BAYFRONT 1 REDEVELOPMENT
PHASE 1A REQUEST FOR BIDS

ADDENDUM NO. 1
MAY 21, 2026

JCRA CONTRACT NO. 26-07-VB1

ADDENDUM NO. 1

LIMITATIONS ON SITE AVAILABILITY

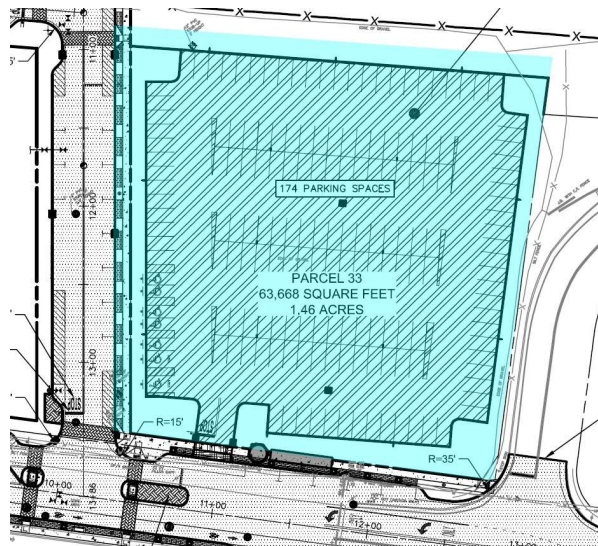
The proposed surface parking lot area illustrated below is not available for Contractor's work until nine (9) months after issuance of a Notice to Proceed.

- **KELLOGG STREET**

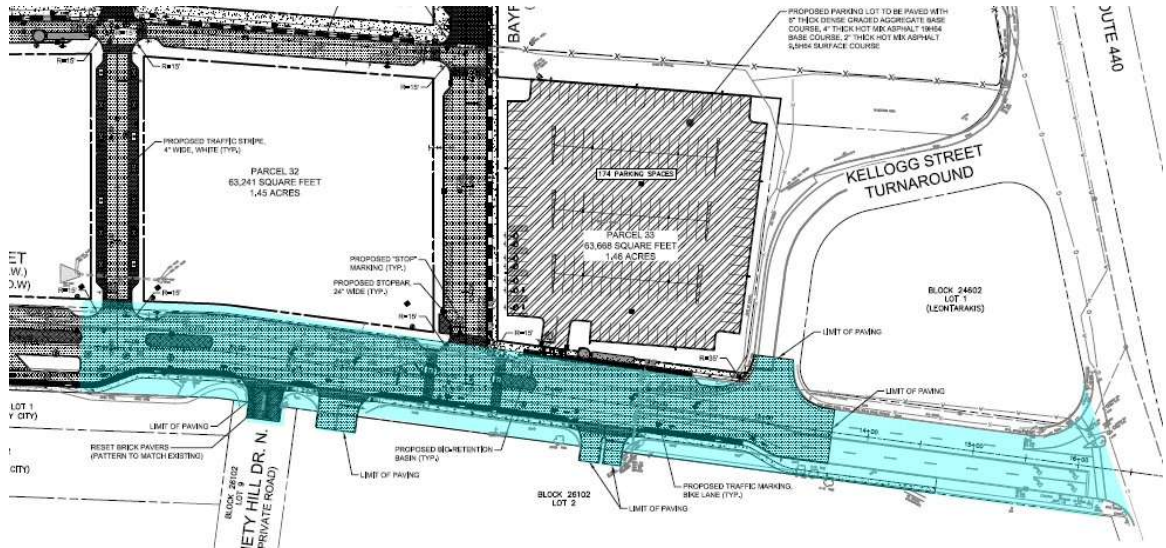
The Contractor shall maintain traffic along Kellogg Street throughout construction, excepting limited overnight closures to facilitate work at the three existing driveway entrances to the adjoining retail shopping center and Society Hill residential development as illustrated below.

- **PARCEL 3 PERIMETER**

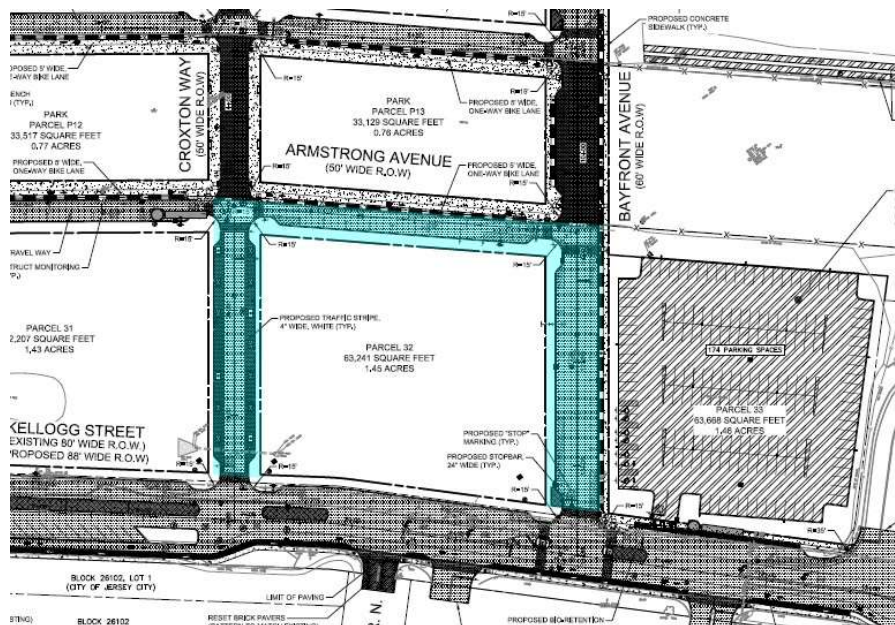
The Contractor will have shared access to the rights of way surrounding Parcel 32 with the Redeveloper of Parcel 32 as illustrated in the figure below. The Redeveloper will utilize the right of way for building construction activities and requires access for activities that include, but are not limited to, crane deployment, concrete truck access, and general access. The Contractor, with assistance from the JCRA, shall exercise reasonable efforts to coordinate with the Redeveloper to reduce conflicts to the maximum extent practicable.

**PHASE 1A INFRASTRUCTURE
CONSTRUCTION TRAFFIC PLAN**

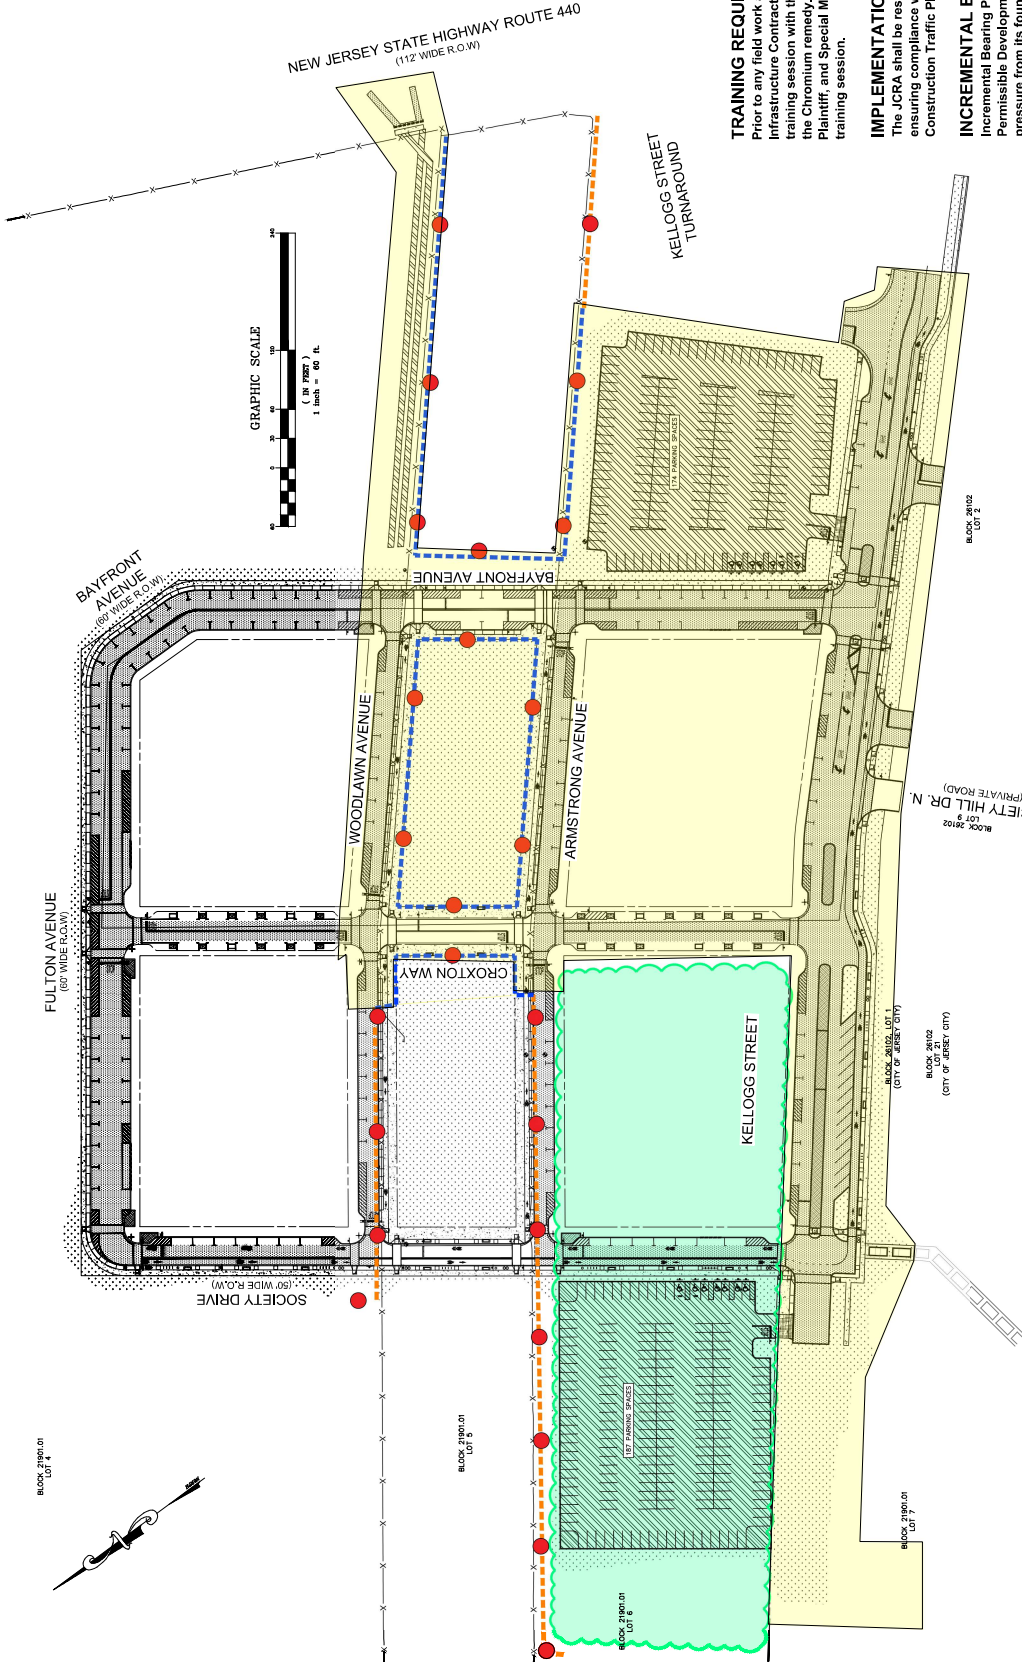
Access to the Open Space Area is strictly limited. The Jersey City Redevelopment Agency (JCRA) will install the improvements identified in the Phase 1A Infrastructure Construction Traffic Plan (attached as Exhibit B) prior to the issuance of a Notice to Proceed and the Contractor shall comply with the Traffic Plan.

Traffic barriers (max. 10 ft space between barriers) 1,880 LF of protection. Barriers may be any length, provided no more than 10 ft of space exists between them. Barriers may be concrete or water-filled type.

Orange construction fencing (1,200 LF)

Pole-Mounted Sign with above-ground concrete base (25 units)
